# Heckington Fen Solar Park

EN010123

## Applicant Response to the Examining Authority's First Written Questions

Document Reference: ExA.ResponseFWQ-D2.V1

Extract from SFRA Level 1 map 'Area D' showing Flood Zones at Heckington Fen (using EA 'flood map for planning' data):

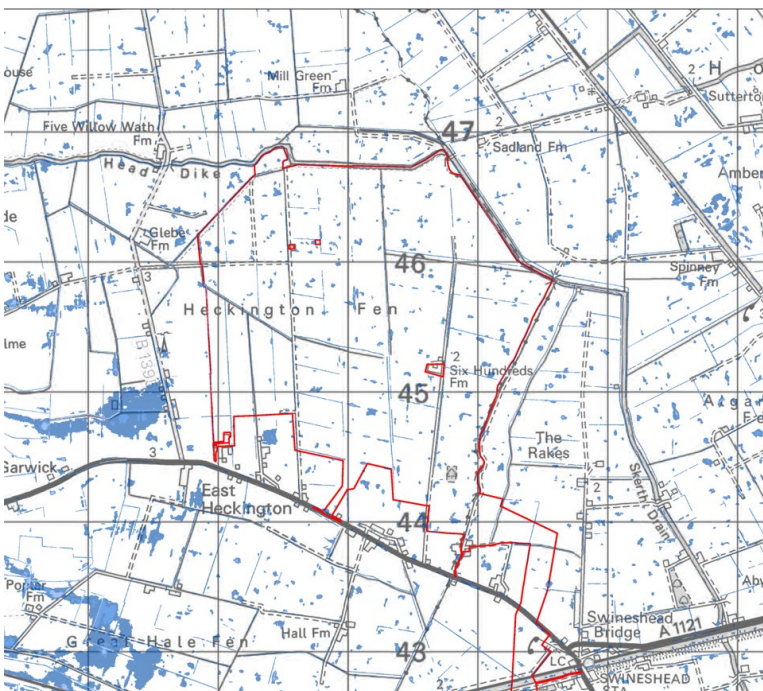
***Could the Applicant provide a copy of the relevant extracts of the relevant versions of the SFRAs which include the Application Site, including title page/introduction of both SFRAs and mapping plans with an overlay of the Application Site.***

## Appendix 2 – Q HE 1.1: Cultural Heritage Plan

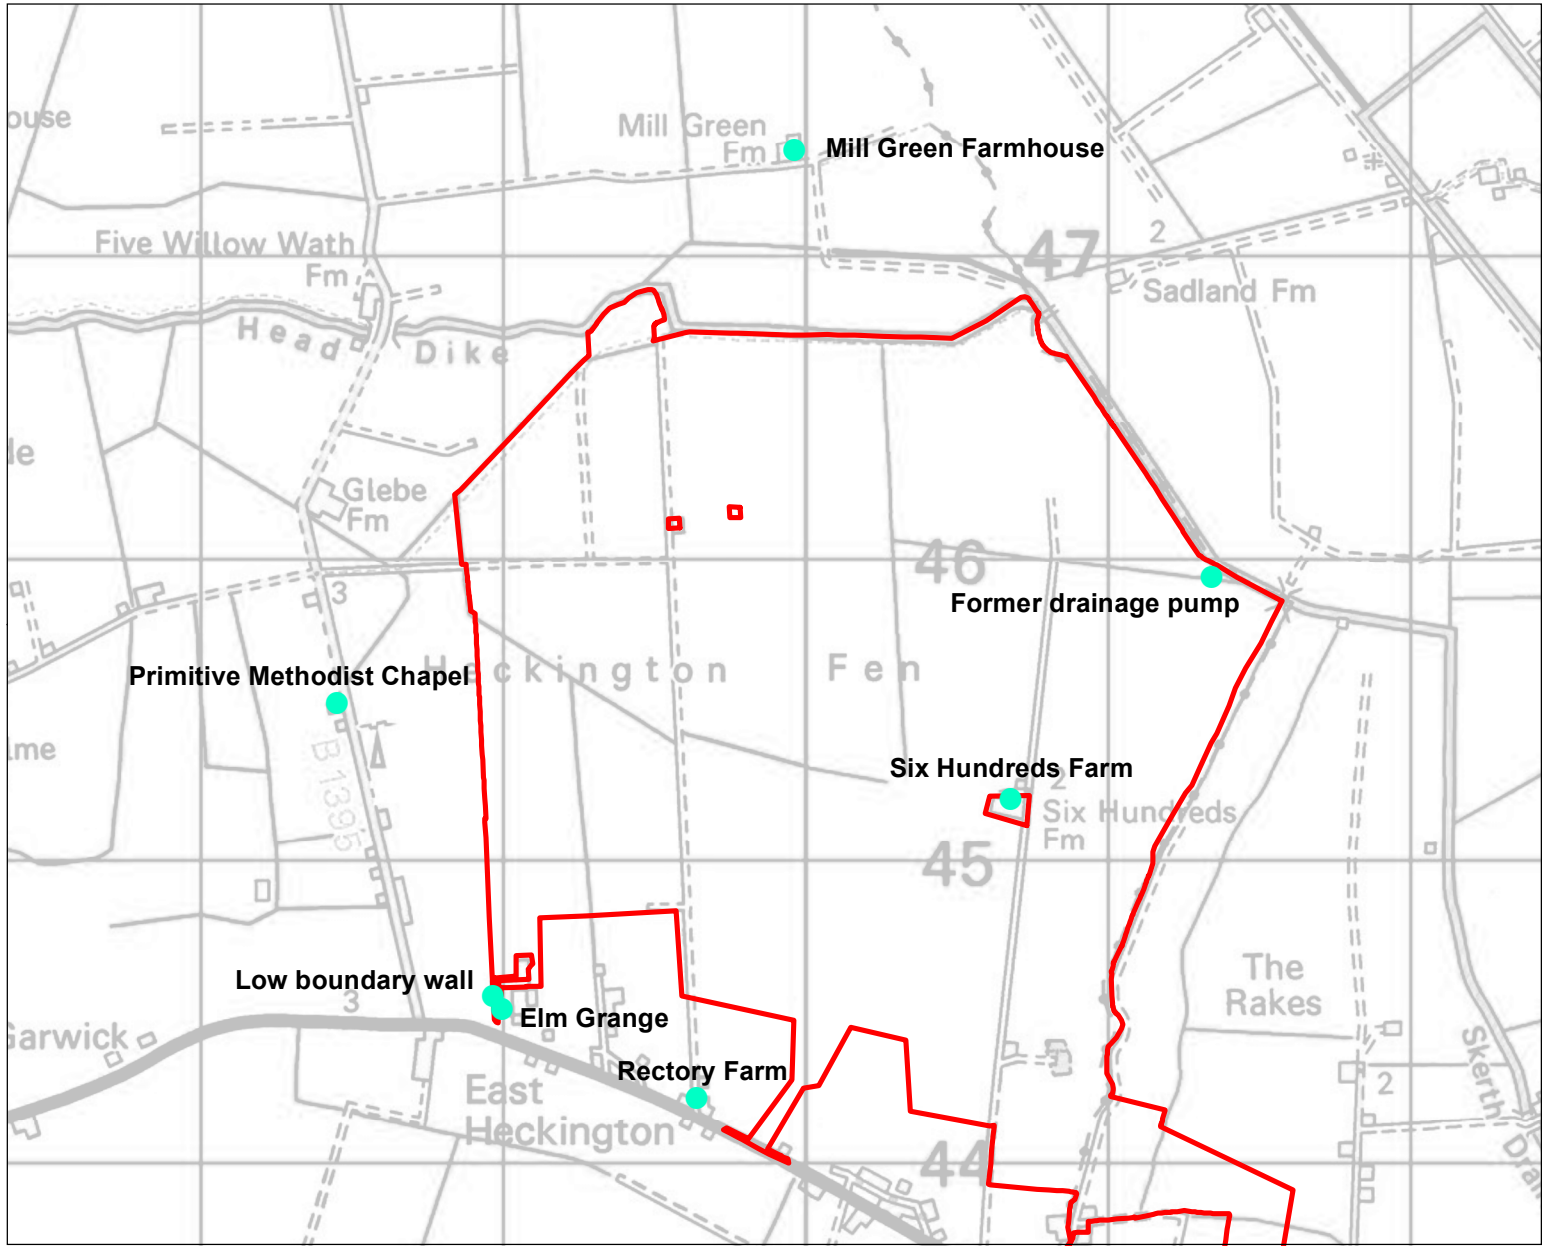
ExA Question Number:	Question Addressed to:	Question	Applicant's Response
HE 1.1	<p>The Applicant</p> <p>Boston Borough Council</p> <p>North Kesteven District Council</p>	<p>ES Chapter 10 [APP-063] includes assessment of heritage assets within a minimum area of 5km. Mill Green Farmhouse, the former Primitive Methodist Chapel, Elm Grange and the Rectory are surrounding buildings within the 5km assessment zone which have all been identified by the Applicant as non-designated heritage assets (NDHA) in the heritage desk-based assessment [APP-206]. The derelict cottages and barn of Six Hundreds Farm, the low boundary wall at Elm Grange, and the former drainage pump at Head Dike are identified as NDHAs within the order land.</p> <p>Could the Applicant:</p> <p>i) Label all of the above-mentioned buildings on a plan.</p> <p>ii) Explain the criteria and or/documentation that led them to identify these buildings as NDHAs.</p> <p>iii) Explain why only Mill Green Farmhouse was considered for further setting assessment but not the other NDHAs.</p> <p>Could NKDC and BBC:</p> <p>i) Confirm if you are in agreement with the identification of the above buildings as NDHAs and that only Mill Green Farmhouse should be considered for further assessment.</p>	<p>i) The following buildings form part of the ‘Monuments’ dataset held by the Lincolnshire Historic Environment Record:</p> <ul style="list-style-type: none"> <li>• Mill Green Farmhouse – HER MonUID MLI121988</li> <li>• Primitive Methodist Chapel – HER MonUID MLI85904</li> <li>• Elm Grange – HER MonUID MLI121956</li> <li>• Rectory – HER MonUID MLI121954</li> <li>• Six Hundreds Farm – HER MonUID MLI121951</li> </ul> <p>They are all marked and labelled with their HER reference number on Figure 4a of <b>Appendix 10.1- Heritage Desk-Based Assessment</b> (document reference 6.3.10/1APP-206).</p> <p>The following structures were not recorded by the Lincolnshire Historic Environment Record at the time the heritage desk-based assessment was prepared (2021), but were identified by the site walkover survey:</p> <ul style="list-style-type: none"> <li>• Low boundary wall at Elm Grange</li> <li>• Former drainage pump at Head Dike</li> </ul> <p>Photographs of these two structures were supplied in Appendices 4 and 6 of <b>Appendix 10.1- Heritage Desk-Based Assessment</b> (document reference 6.3.10/1APP-206).</p> <p>ii) A plan showing the locations of all of the above mentioned buildings and structures is provided at <b>Appendix 2</b>. Planning Practice Guidance (2019) defines non-designated heritage assets as follows:</p> <p><i>“Non-designated heritage assets are buildings, monuments, sites, places, areas or landscapes identified by plan-making bodies as having a degree of heritage significance meriting</i></p>

## **Appendix 4 – Q BIO 1.2 ii : Bicker Fen Substation Overview Plan**

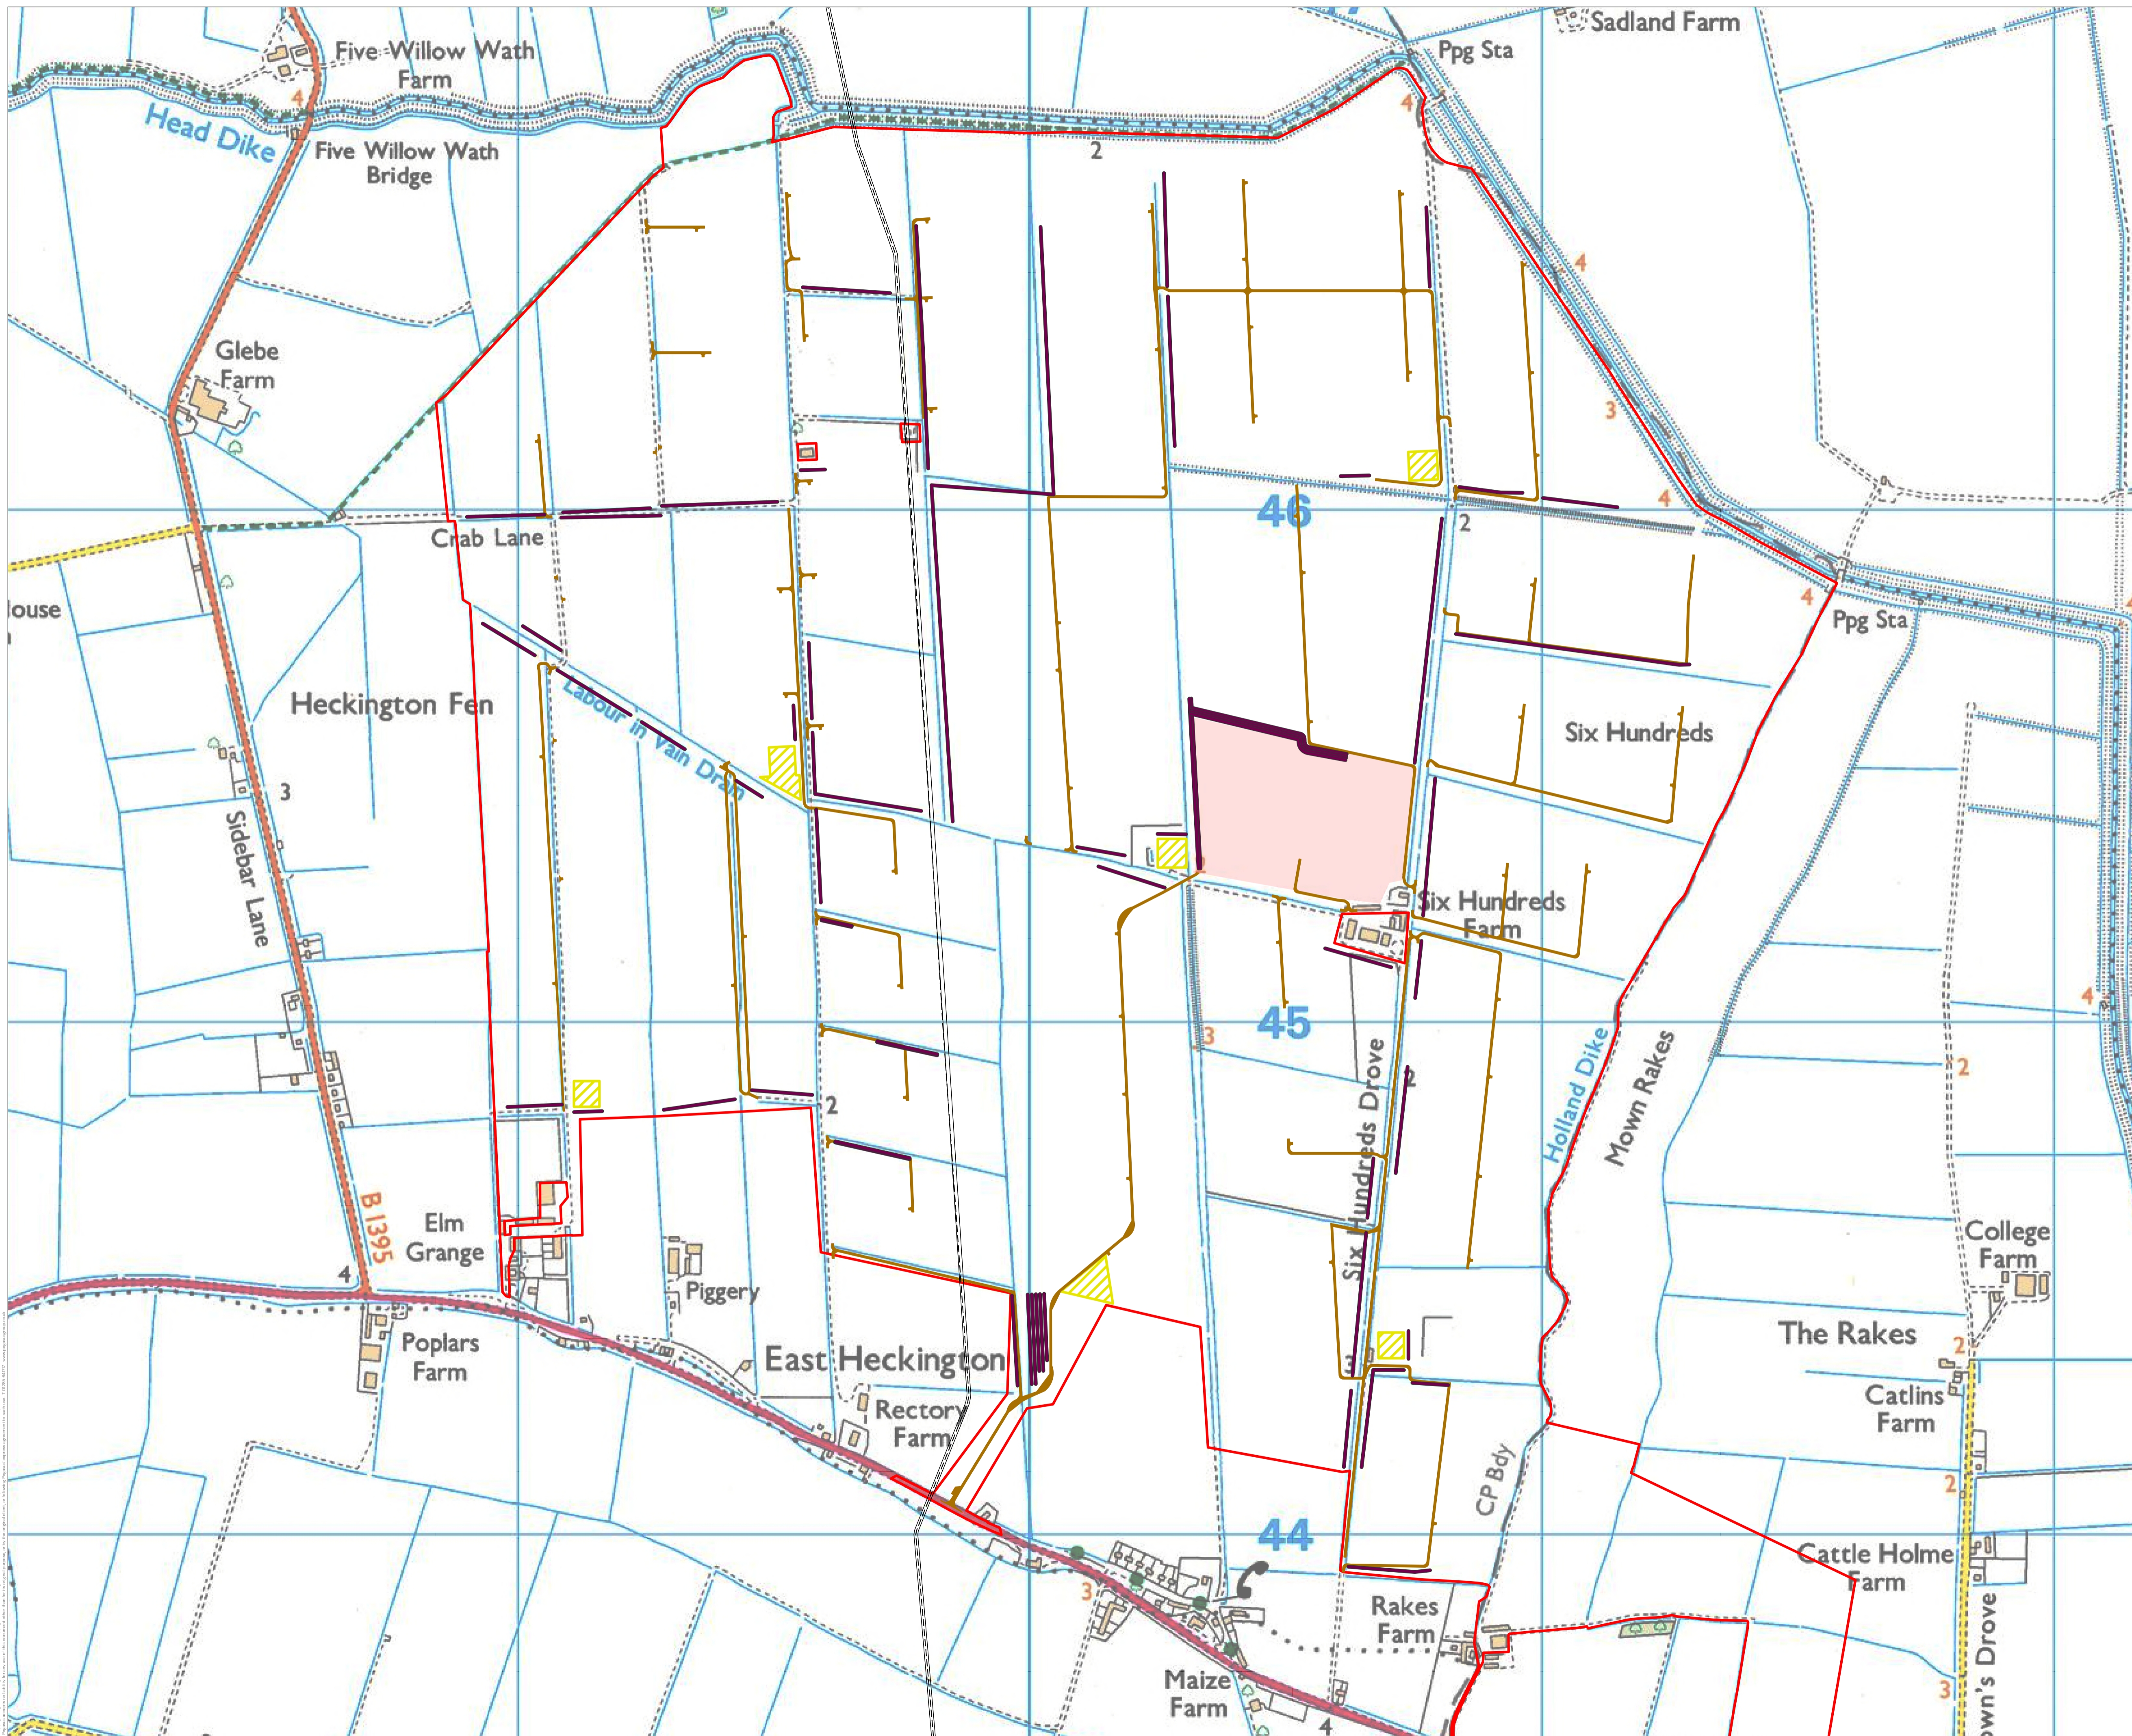
<p>BIO 1.2</p>	<p>The Applicant and National Grid Electricity Transmission Plc</p>	<p>The Landscape Strategy Plan [PS-091] details landscaping proposals for the energy park site only and not the Bicker Fen substation. The accepted Change Application shows an area of mixed species plantation is proposed to be removed to enable additional substation infrastructure. This is further considered in the Change Application documents [PS-003 onward] which state that ‘replacement tree planting has not been possible at Bicker Fen substation due to technical constraints and limited land availability’. At Issue Specific Hearing 2 (ISH2) [REP1-020] it was indicated that there are numerous constraints to planting including location of cables.</p> <p>Could the Applicant and National Grid Electricity Transmission Plc (NGET):</p> <p>Grid i) Provide further details/plans on the extent of loss of mixed species plantation woodland to be removed to the south-west corner of Bicker Fen substation, with an indication of minimum and maximum area of loss for a) a GIS system and b) an Air Insulated Switchgear (AIS) system.</p> <p>ii) Provide a more detailed explanation as to why planting around the Bicker Fen substation is not appropriate and has not been included in the plans.</p> <p>iii) Give further consideration as to whether off-site planting in the vicinity of the substation (or a contribution to third party planting) has been considered, which potentially could be secured via legal agreement.</p>	<p>i) <b>Appendix 8.13- Further Extended Phase 1 Habitat Survey Report- Bicker Fen Substation</b> (document reference Pre-ExA.ChangeApp.ESAPP8.13.V1/ PS-153) contains details of the mixed species plantation and the percentage loss of each type of tree. It is not possible at this stage, and prior to detailed design being undertaken, to indicate a minimum area of loss but as a comparison we have indicated the areas of loss for a GIS system and an AIS system as requested.</p> <p>A maximum footprint for the Gas Insulated Switchgear will be approximately 5,625m<sup>2</sup> (e.g., 75m by 75m). Some Switchgear apparatus will be housed indoors in a building 30m by 20m, and 15m in height. All of the infrastructure for the Gas Insulated Switchgear option will be in the footprint of Work No.6A and Work No.6B as shown on the <b>Works Plan</b> (document reference 2.2 / PS-014).</p> <p>The Air Insulation Switchgear will be approximately 14112m<sup>2</sup>, and 15m in height. All of the infrastructure for the Air Insulated Switchgear option will be in the footprint of Work No.6A and Work No.6B as shown on the <b>Works Plan</b> (document reference 2.2 / PS-014).</p> <p>ii) Consideration has been given to providing additional planting within NGET land. However, the substation site already has a planting plan imposed as part of a landscape condition for the original substation (Boston Borough Council application reference 05/0046). This accounts for woodland and tree planting to the north and western boundaries, and a wetland area to the south eastern corner. The remaining land is either constrained by existing infrastructure (e.g. pylons, cables) or is required for further development in the future and therefore should not be further constrained limiting the ability for other customers to connect to this site in the future. This statement is supplemented with a plan at <b>Appendix 4</b> of this document.</p> <p>iii) The Applicant confirms consideration continues to be given to a number of options to satisfy Boston Borough Council’s concerns</p>

<p>that the replacement tree planting being provided on the Energy Park is not adequate because it is not within BBC's area.</p> <p>These include planting along the southern boundary of National Grid Bicker Fen Substation in the highway verge. This would need to be agreed with Lincolnshire County Council highways. This area is not large enough to replicate the total area of planting loss at National Grid Bicker Fen Substation and has not been progressed to date although this remains possible if agreement can be reached that it would satisfy BBC (which to date they have indicated it would not).</p> <p>The land noted by Black Sluice Internal Drainage Board at Issue Specific Hearing 2 on the 20<sup>th</sup> September 2023 for potential plantation is already underway and the trees will be funded by a grant, as such this cannot be progressed and a contribution to help maintain the new woodland is not likely satisfy BBC's requirements.</p> <p>A further option is a designated tree planting charity, for example Boston Woods Trust. The Trust confirms they only plant trees close to Boston, and when they have sufficient land available to them. BBC consider that this location is too far away to be associated with the loss of trees at National Grid Bicker Fen Substation.</p> <p>The Applicant continues to explore options to satisfy the request of Boston Borough Council but would reiterate that planting is included in the Energy Park within a separate woodland parcel and within hedgerows on the northern boundary which will replace the tree loss at the Bicker Fen Substation when considering the project as a whole.</p>
